CO-03-06 BACKUP

Hancock Road Phase III A and IIIB

FDOT ADA Ramp Modifications: Due to steep profile slope of the Trail ramps had to be extended to conform to FDOT ADA construction requirements. Plans indicated ramp width from 10' to 11.5'. To match trail width ramps were constructed at typical 12' width. Required adjustments increased trail ramp 4" concrete quantity and Detectable Warning Surface (DWS) quantity. Additionally, two (2) each DWS's not shown for installation at the median safe haven by the original bid plans are included as part of this item CO-03-06.

EXHIBIT 6 BACKUP DOCUMENT

Old 50 East

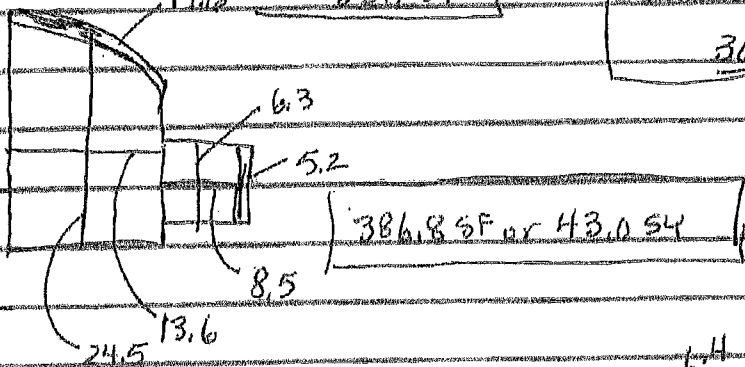
$264.4 + 63.0 = 327.4 \text{ SF}$
 36.4 SY

Old 50 East West Ramps are the only locations where there is no asphalt offset related to additional concrete for ramps. I get increase in concrete at these ramps at 85.4 SY. This quantity includes SW ramp construction twice. Bid A unit cost is at \$23.50/SY. Increase in cost is at \$2,453.20.

Old 50 West

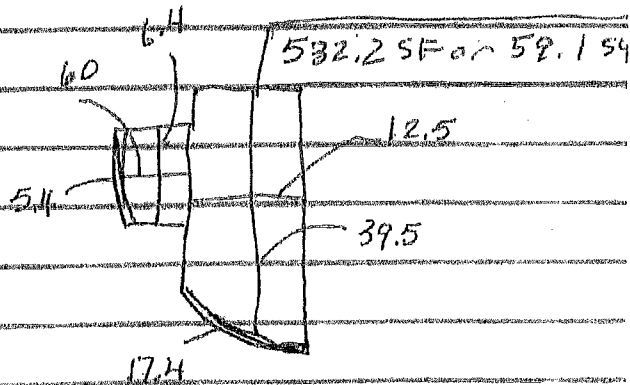
$567.8 \text{ SF or } 63.1 \text{ SY}$

School Main Entrance

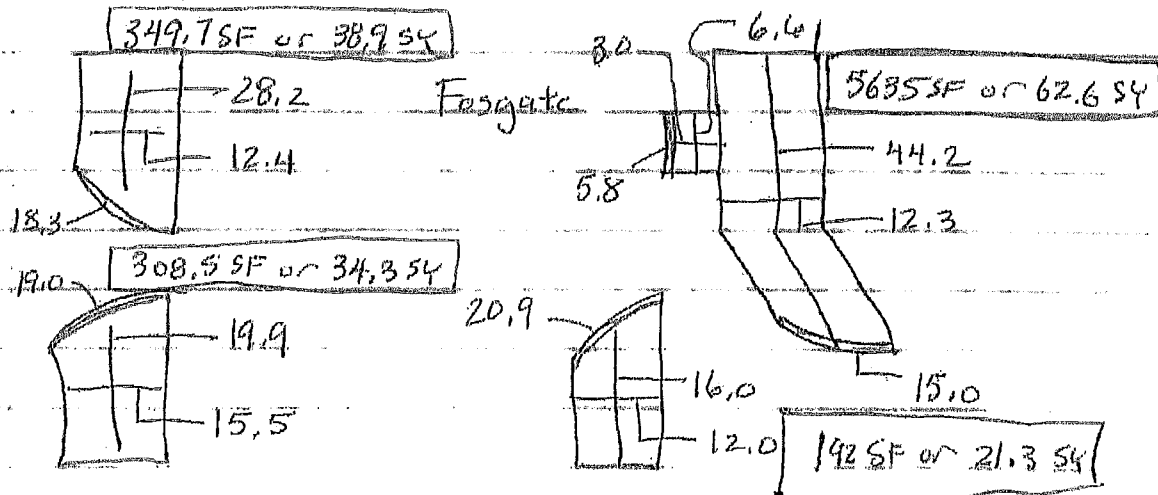
Added Two (2) DWS's at School Main Pedestrian Crossing not shown for installation by the original plans. Unit cost of DWS per part A of the contract is at \$500.00/EA.

There are three curb ramps that were shown with no DWS. All in bid A area at \$500.00/EA. There is two ramps / DWS's not installed at STA 2364+ Right. The actual plan number of DWS's in bid A was 357. Bid noted 34. Plan and bid B at 6 DWS's. Concrete was not there to measure so it adjusted itself with sum. There are 47 DWS's rather than 40. Add 2 DWS's at \$500.00/EA for a total cost of \$1,000.00.

Increase work 2 DWS $\times \$500.00/\text{DWS} = \$1,000.00$.
